State of Alaska
Department of Fish and Game
Nomination for Waters
Important to Anadromous Fish

Anadromous Water Catalog Number of Waterway 103-60-10505

Name of Waterway Pump House Creek USGS name ___ Local name X

Addition ___ Deletion ___ Correction X Backup Information ___

CRAIG (B-4) QUADRANGLE
ALASKA
1:63360 SERIES (TOPOGRAPHIC)

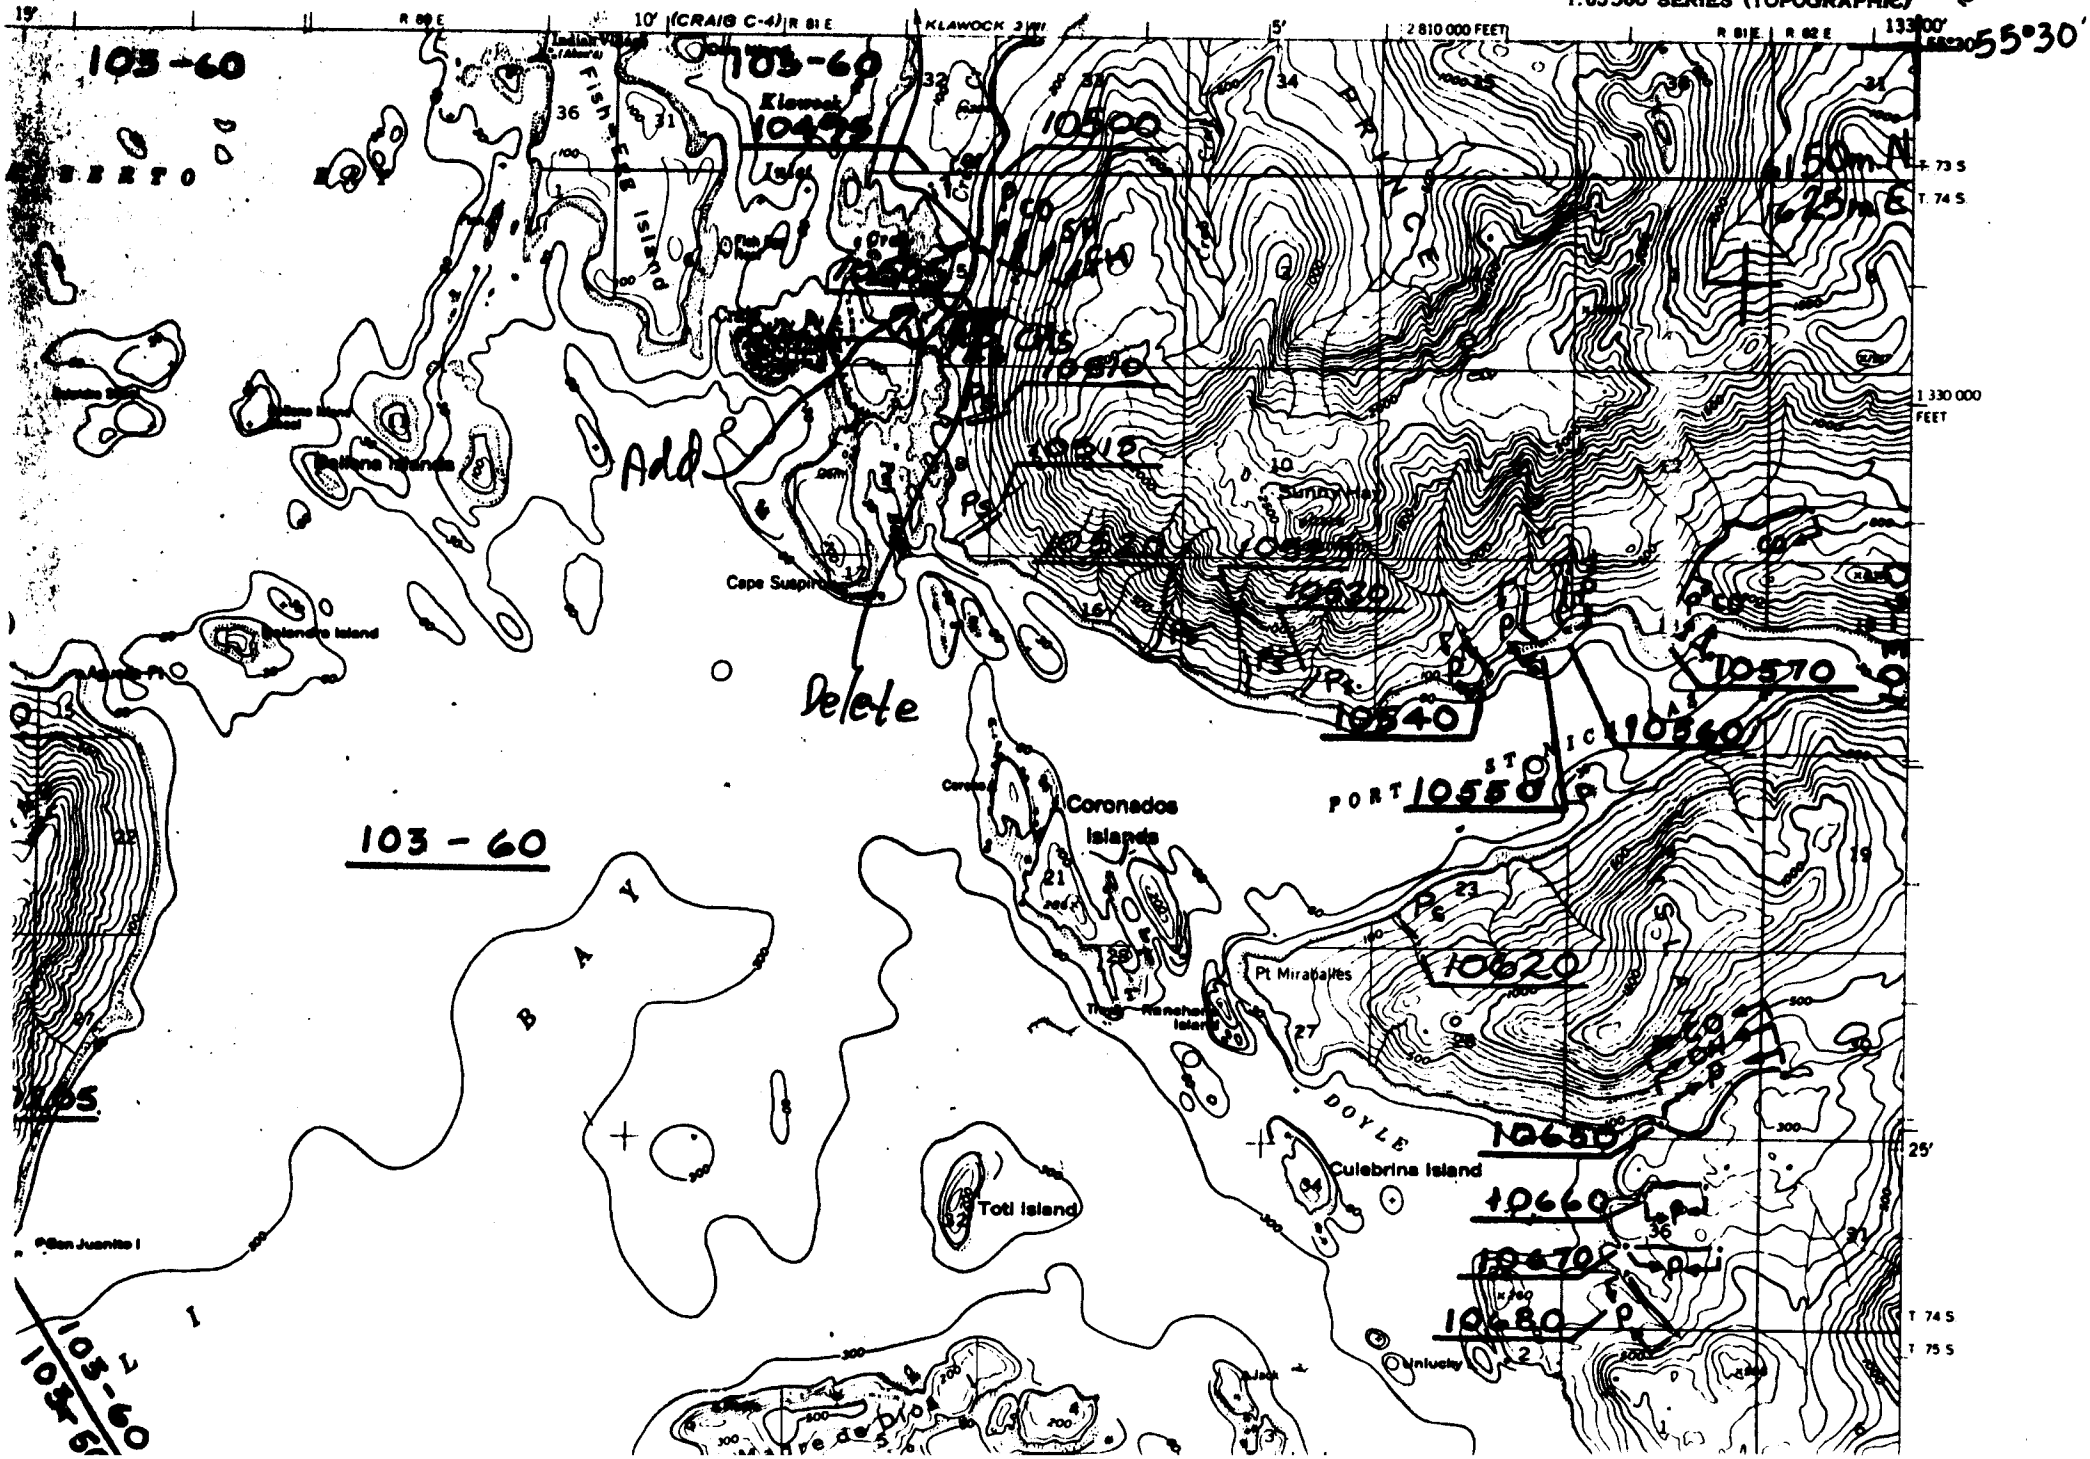
Stream as drawn is composite of two streams. Lower end belongs to stream which may well be anadromous, but becomes too steep after crossing under Port St. Nicholas Rd. Upper portion is stream which has been heavily impacted by logging above it. DOT just put in major culvert designed to pass fish. Separate streams, + shorten the upper end. One with new culvert is locally known as Pump House Cre
